East Richmond Neighborhood Council

August 20, 2024

Traffic Safety Study Comments and Requests - 12300 San Pablo Ave. - Dollar Tree Conditions of Approval

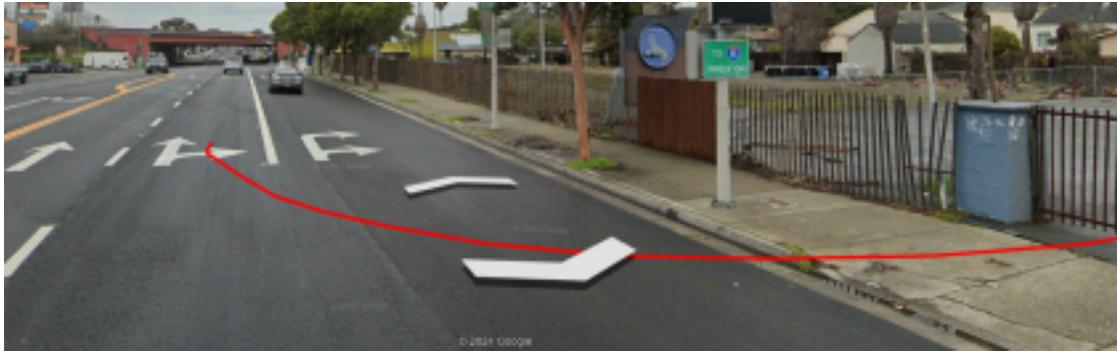
Issue: This issue came up during Planning Commission hearings, but the applicants argued against adding a center median in favor of allowing large delivery trucks to turn into the parking lot from the north on San Pablo. During recent construction at the site we observed a worker crossing northbound San Pablo lanes to exit the site and go south on San Pablo Avenue, indicating that - without a center median - this practice will be an attractive shortcut to some patrons, too.

Also, please comment on the safety risks of the applicant's plan to have large delivery trucks come in from the north on San Pablo Avenue and take a left turn into the parking lot as shown in the above photo.
